2223
1
17TH AUGUST 1891, No. 2223 W., PUBLIC WORKS.

GOVERNMENT OF MADRAS.
PUBLIC WORKS DEPARTMENT.

Police Station-house at Jagannadharajapuram, Vizagapatam District

Orders regarding the failure of the — built under the supervision of Mr. Sub-Engineer T. T. Raghavachariyar.

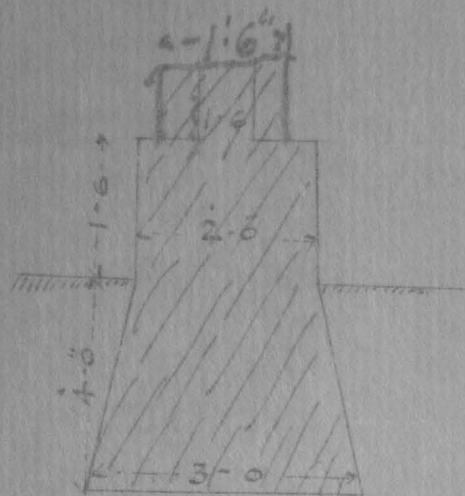
I examined the buildings of the Lunatic Asylum. The walls of almost all of them are cracked, and in several instances very badly so. I attribute this to defective drainage, insufficient width of foundations, and to the fact of the foundations

2 The buildings are on sidelong ground of a porous sandy description and the variations from wet to dry must be frequent and extreme. The form of foundation for the main walls is given in the sketch. The verandah and other smaller foundations are 2'-9" wide and 3' deep, as the main walls are 16' high and 1'-6" thick of rough stone in Chumam it is evident that these foundations are very small compared with those of the standard police station where the foundations are 4' wide 4' deep, and carry walls 10'-6" high

3 The foundations too being built entirely of rough stone, probably from the first never had a full bearing on the ground. The rubble work here I have noticed is generally very bad and the interiors of the walls are full of open spaces. Drainage water intercepted by the foundations, and finding its way through any cracks that may have formed would be conducted down to the ground under the foundations and go far to encourage unequal settlement.

Police Station at Kuaupau
Rough Elevations showing
position of cracks.

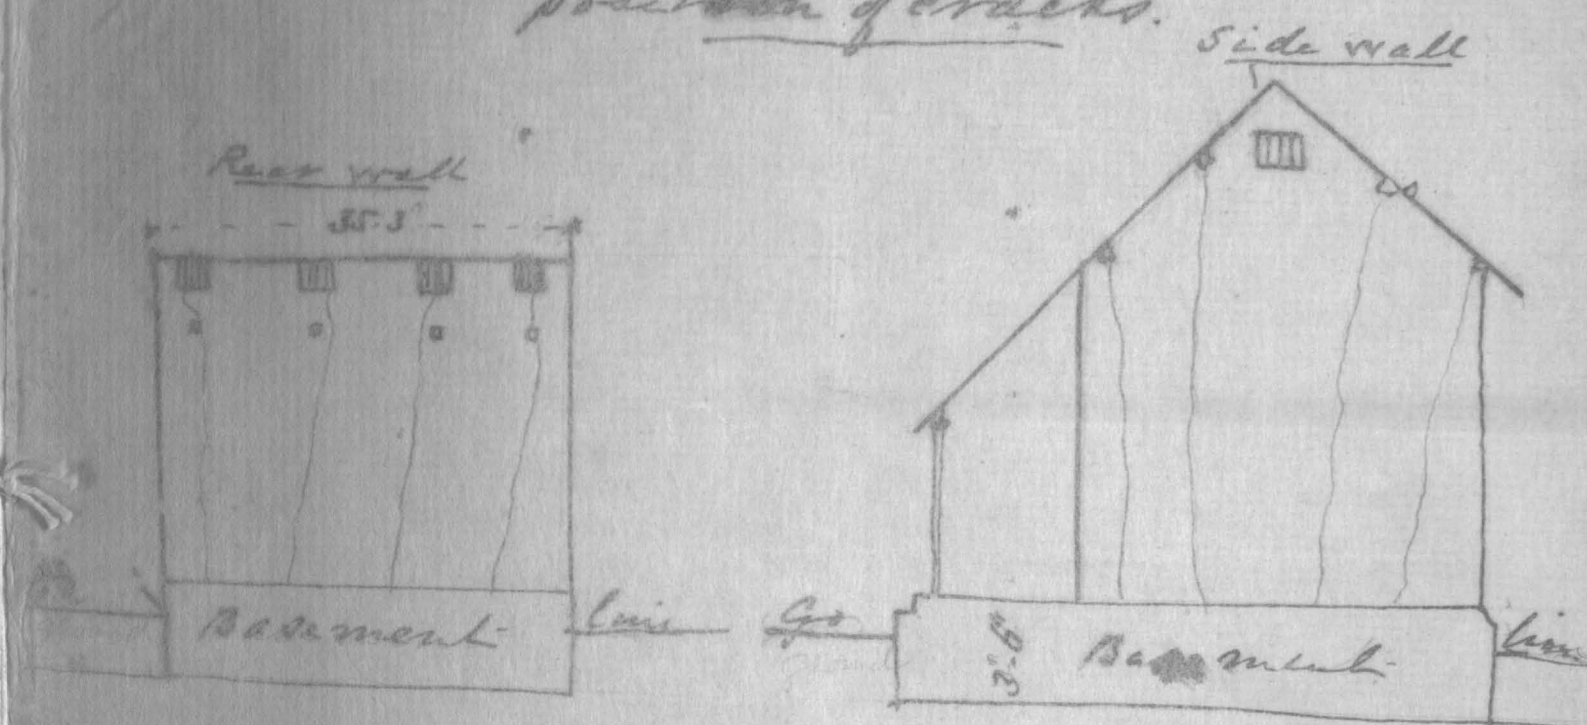
This is on the same design as above but has four light
cracks on the rear wall and four more but very slight on
the south side wall (gabled) as shown in the rough elevation
annexed.

The cracks on the rear wall are visible both inside and
outside but are so slight as not to be considered serious.
On examining the foundations none of the cracks appear
to have extended below the top of basement which
together with the foundations consist of rough stone
in chunam while the superstructure is of Brick in
Chunam. The walls are plumb, workmanship as
fair

fair as can be expected in an out of the way agency station and bricks fairly good. The mortar used seems indifferent and to this I attribute the cracks on the rear wall. The reflecting on purlins being nailed on there could not be much lateral thrust and if the mortar used had been made of fresh lime would have set properly and the cracks could not have been formed.

The cracks in the outside wall are not visible inside they start in each case from a purlin and are due to the absence of stones under the purlins to distribute equal pressure also bad mortar.

Besides the above cracks there is one on the crown of the segmental arch of the entrance door and another by its side, but not serious, these are due to the settlement of the arch and must have appeared soon after the completion of the building.

It is reported that all the cracks above described have been in existence there last three years and have not shown any signs of enlargement. I consider them to have properly settled and require but to be raked out and filled in with Chinaman grout.
